# PKG RL Ad-Hoc Summary

# PKG Return Loss Ad-Hoc Group

# Submitted Comments

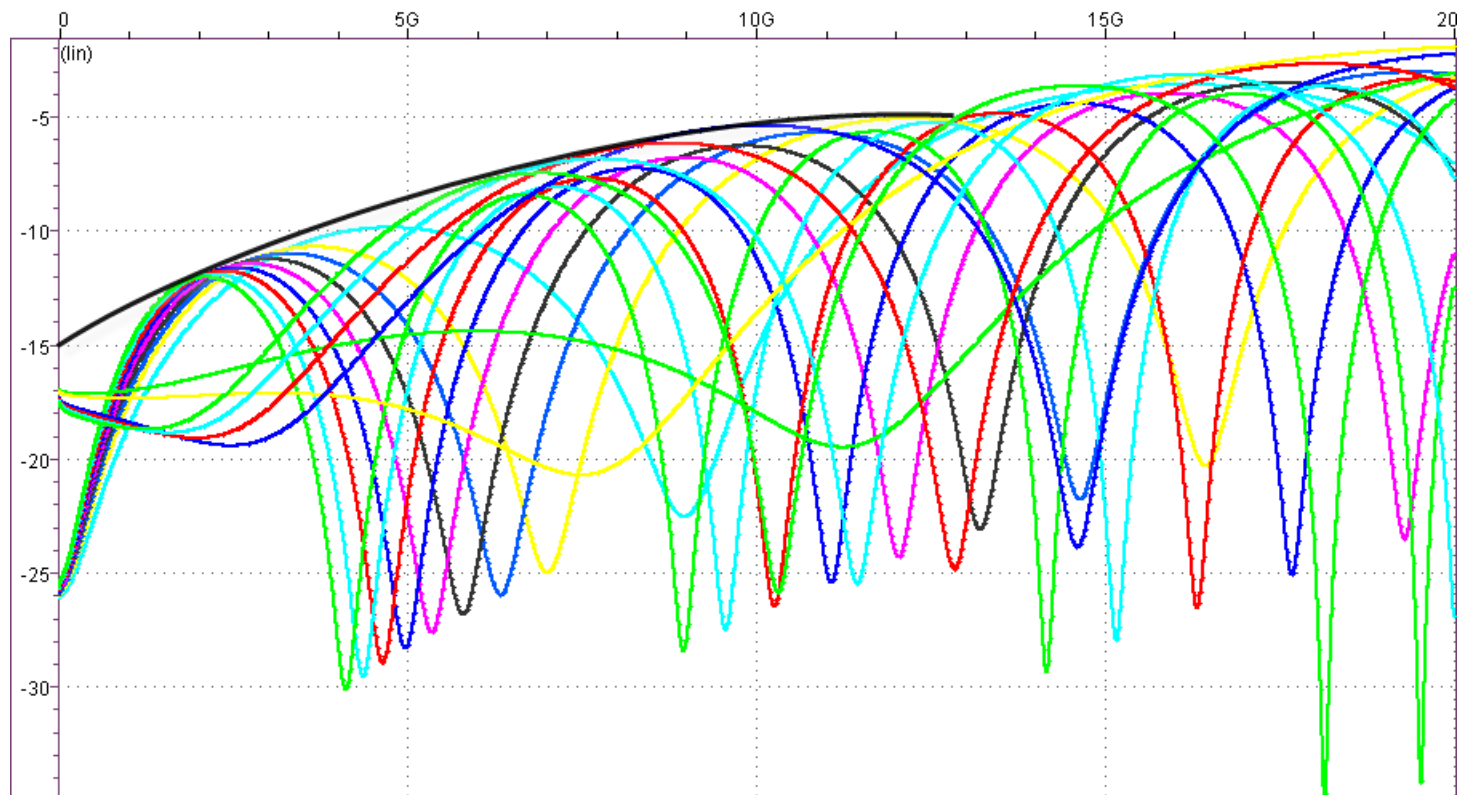
- #38: The return loss equation for TP0/TP5 as described in Eq: 93a-3,4,5 and table 93a-2 is not coherent (consistent) with the measured return loss at TP0a/TP5a as described in equations 93-2, 93-7, 94-5, 94-15 as well as with cable return loss as described at equations: 92-1 and 92-5.
  - The Conclusions Also Address:
    - Comment 129 and 132 : Transmitter return loss mask
    - Comment 132: Receiver return loss mask
- as submitted by Ali Ghiasi.
- Comment #29: Return loss equation by Charles Moore
  - Comment #104: Return loss frequency range by Piers Dawe

- Replace equations 93-2, 93-7, 94-5, 94-15 with the described @ slide #15. Limit the frequency range for clause 94 to 10GHz.
- Remove equations 93A-3 through 93A-6.
- Remove table 93A-2
- Add a PKG model section with the phases:
  - Estimate differential s-parameters for a small segment of uniform lossy transmission line (Mellitz\_3bj\_01\_0113 slide#5)
  - Create s parameters for pad and ball (Mellitz\_3bj\_01\_0113 slide#7)
  - Combining Parameters to create PKG and End2End model (Mellitz\_3bj\_01\_0113 slides#8-9)
  - Add a table of PKG model values per slide 13 (in current presentation).

# PKG Alteration Runs

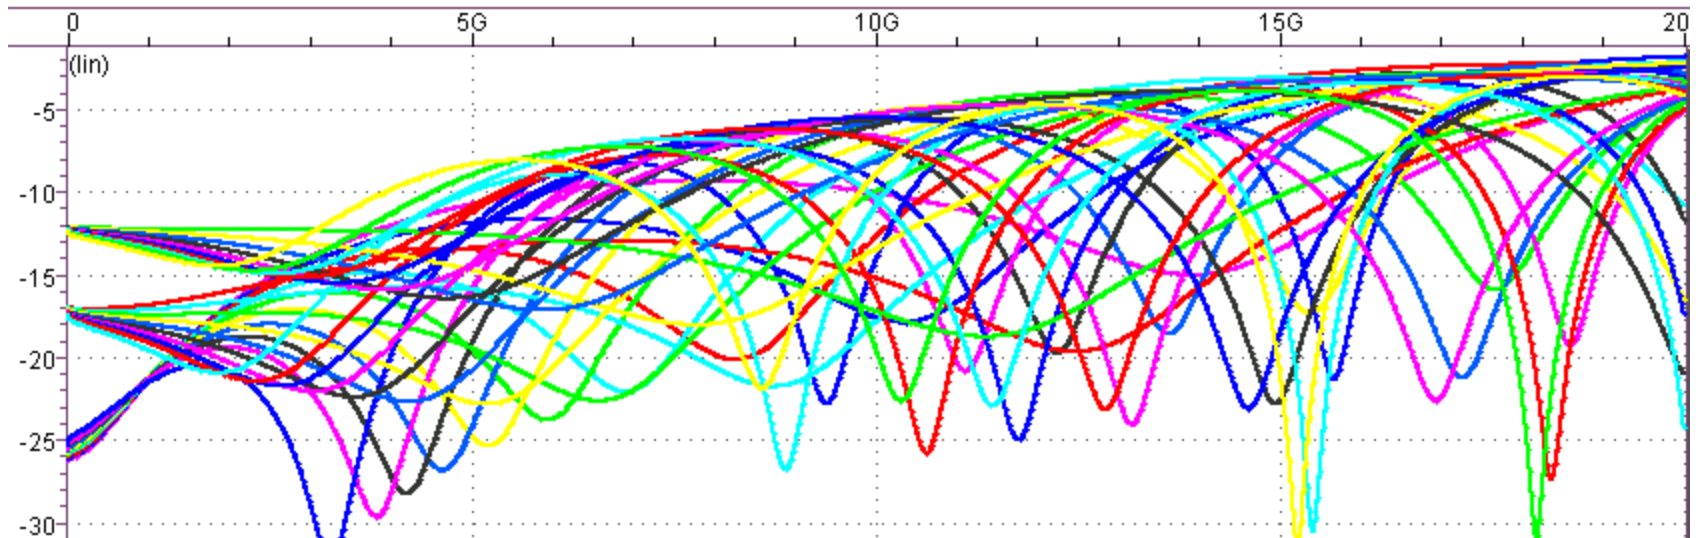
- 100ohm PKG

- Main issues are:
  - high frequency Ret-loss of  $\sim 4.3$
  - Insertion loss of 3.3dB

# PKG Alteration Runs

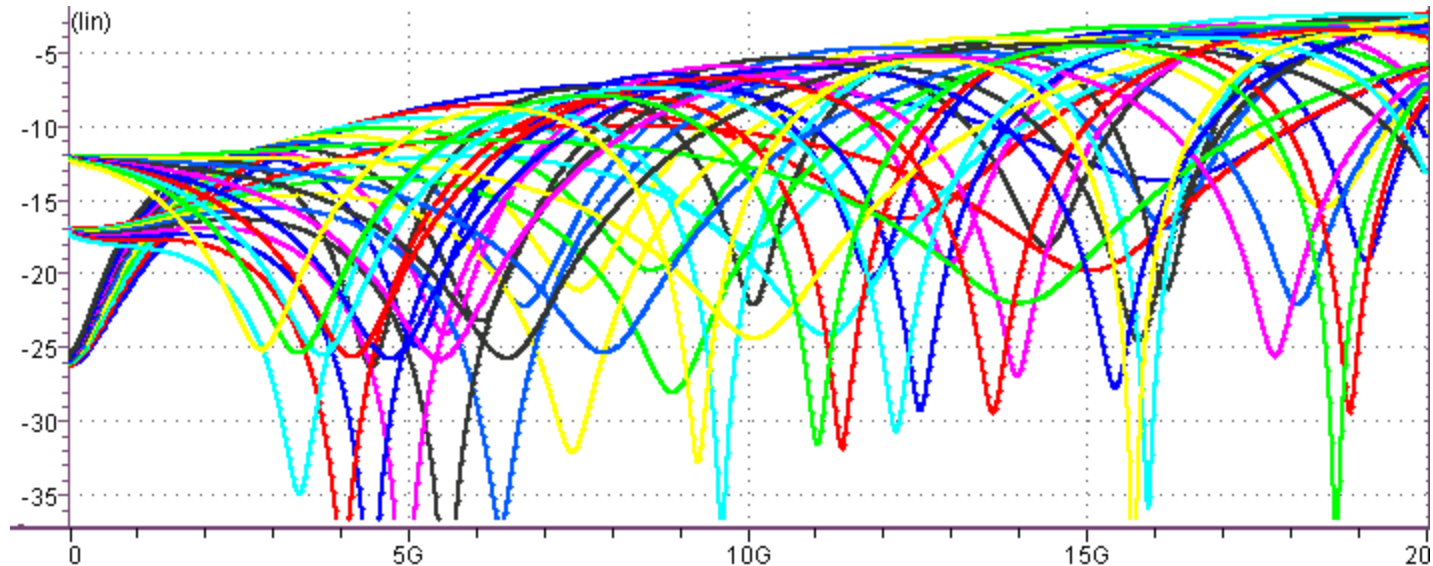
- 83ohm PKG

- Main issues are:

- high frequency Ret-loss of  $\sim 4.6$
- Low freq (2GHz) ret-loss of 11.5dB
- Insertion loss of  $\sim 3.1$ dB

# PKG Alteration Runs

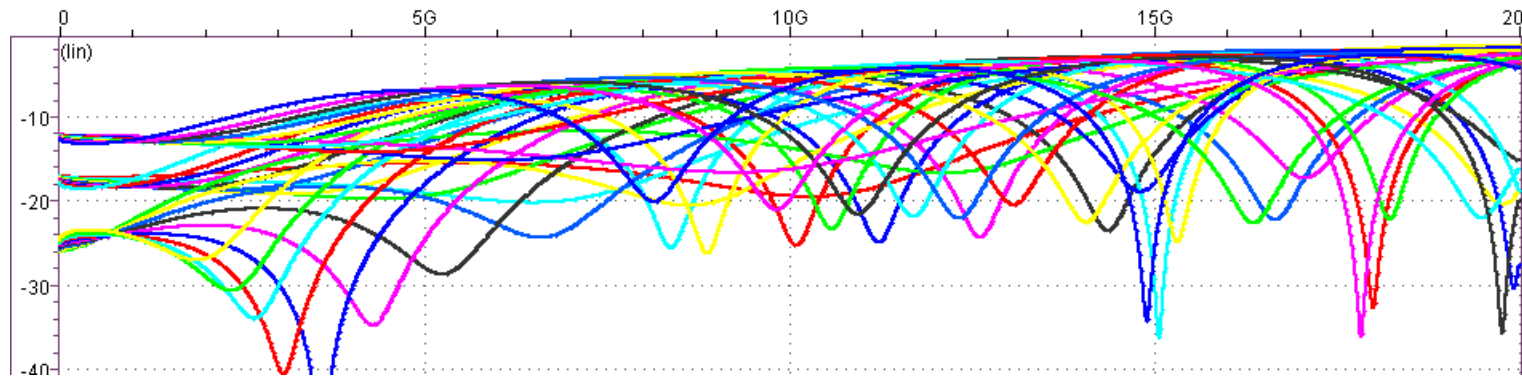
- 115ohm PKG

- Main issues are:
  - high frequency Ret-loss of  $\sim 4$
  - Low freq (2GHz) ret-loss of  $10.9\text{dB}$
  - Insertion loss of  $\sim 3.7\text{dB}$

# PKG Alteration Runs

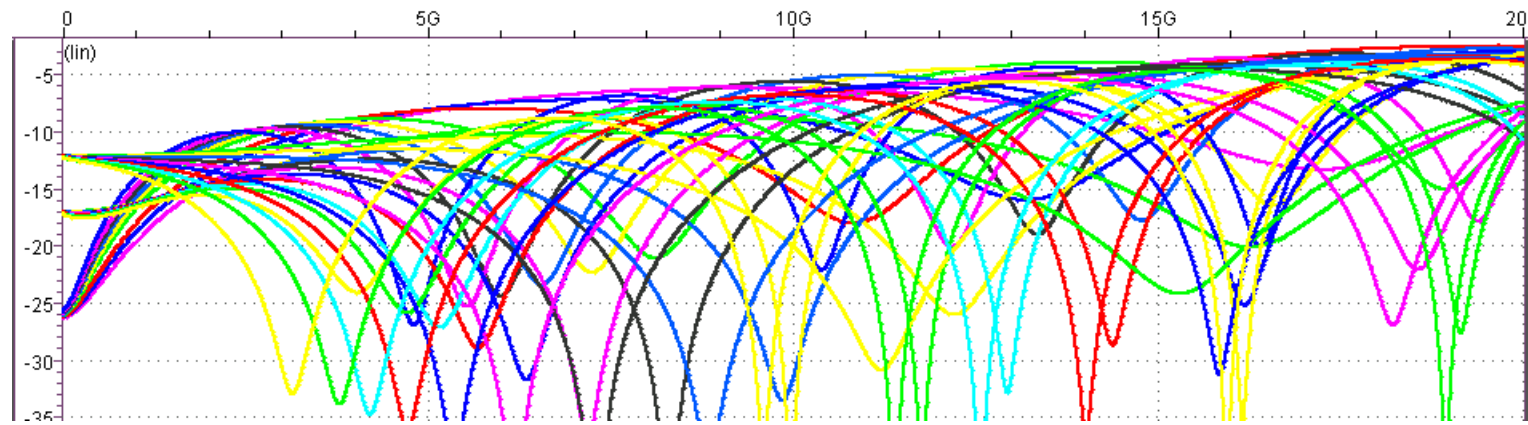
- 75ohm PKG (for the case of tuning PKG impedance lower for lower Tx impedances.)

- Main issues are:
  - high frequency Ret-loss of  $\sim 4.7$
  - Low freq (2GHz) ret-loss of  $\sim 10.5$ dB
  - Insertion loss of  $\sim 3$ dB

# PKG Alteration Runs Conclusion

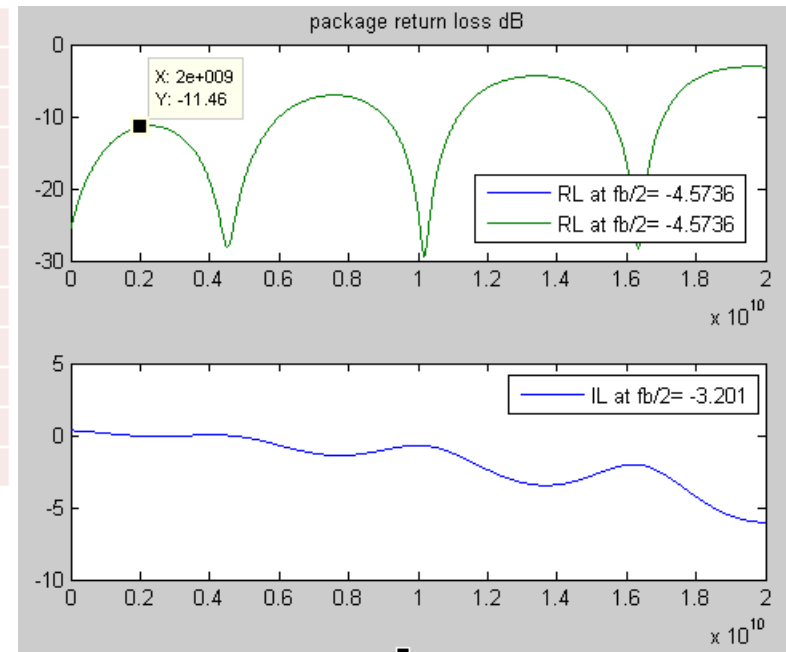
- The worst case is the 115ohm PKG impedance resulting in extra PKG insertion loss, 4dB return loss @ 13GHz as well as 10.9dB return loss @ 2GHz.
- Recommend tuning the COM return loss to ~11.5dB @2GHz and ~4.5dB @ 13GHz and PKG insertion loss to ~3.2dB.
- The above recommendation is not the worst case observed...

# Measured RL @ TP0a with PKG Impedance Tolerance

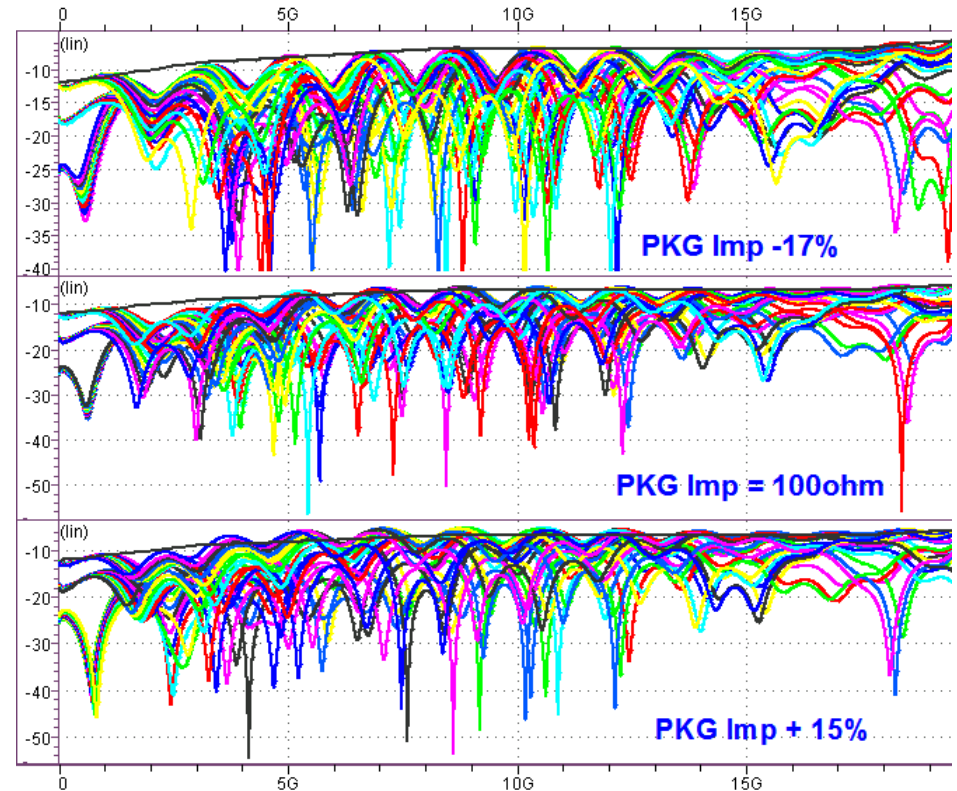
- The measured return loss (TP0a/TP5a) was simulated taking into account PKG manufacturing tolerance and worst case fixture.
- A suggested remedy on next slide

# TP0a Suggested RL Limit

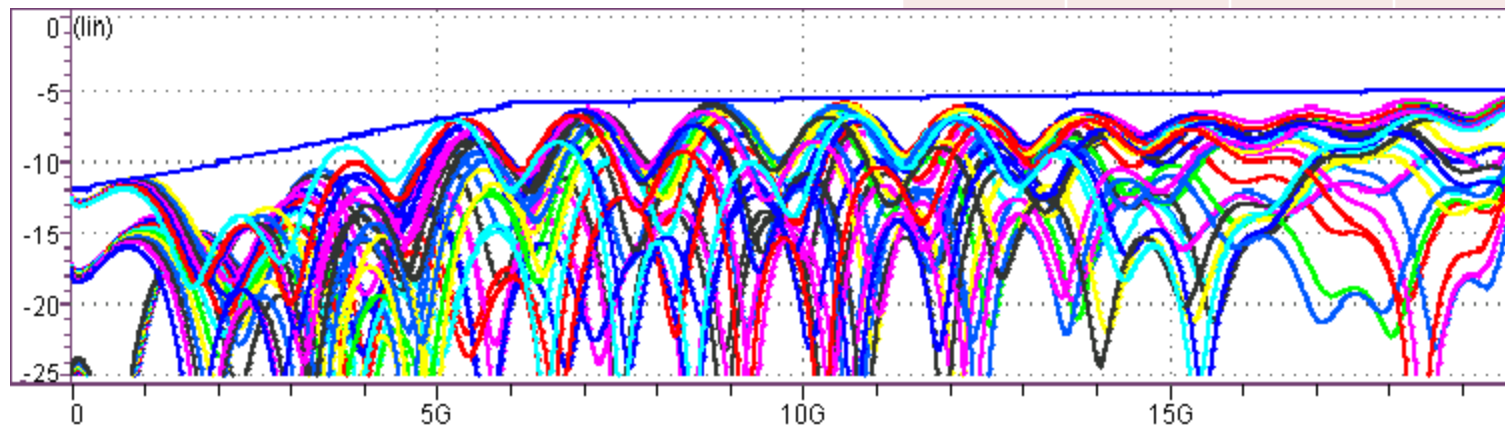
- Suggest that the measured return loss @ TP0a/TP5a be higher than:  
RL@TP > aF + b (F in GHz) between F1 and F2
- Excluding the combination of high impedance PKGs + low impedance driver one can get:  
(Still allowing a low impedance driver)

F1	F2	a	b
0.05	6	-1	12.05
6	19	-0.075	6.45

# Molex Cable End-to-End COM results

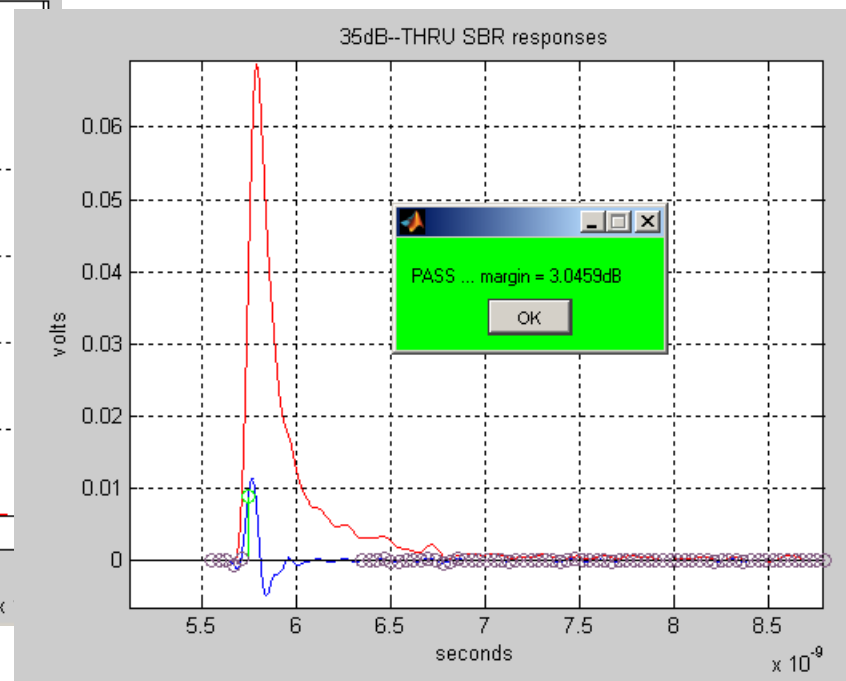
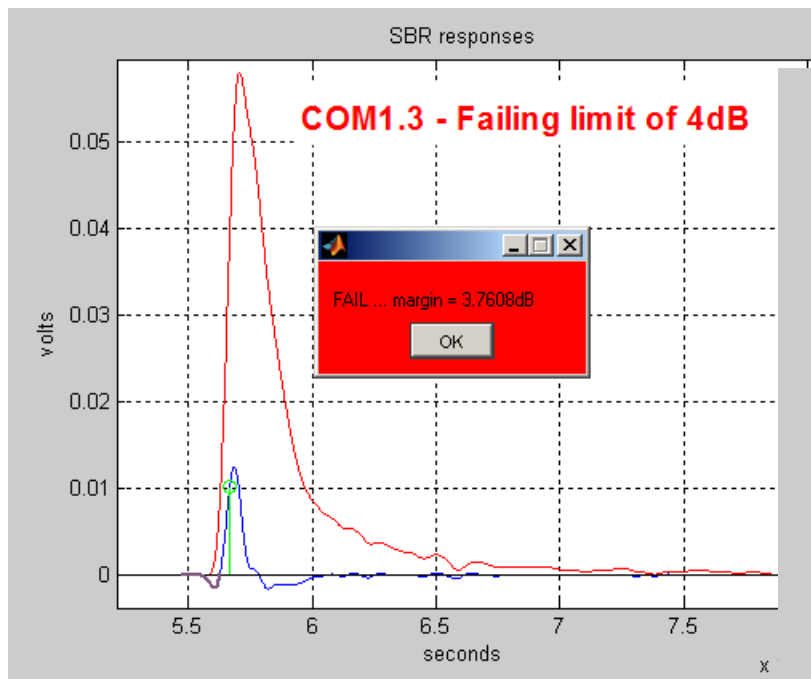
- Molex Cable\_a was ran in COM with suggested RL and resulted in passing COM margin.
- $(110\Omega \text{ host board model} + \text{two vias}) * 2$  were added to the bare cable model to get it close to 35dB @ 12.89GHz.
  - The via models represent the device break-out vias + cable connection vias. The trace was taken to the manufacturing tolerance of +10%.
- Model lacked host board Xtalk, but resulted in high margin after board concatenation.
- COM1.3 resulted in 0.64dB margin. → Current suggestion margin = 1.21dB.
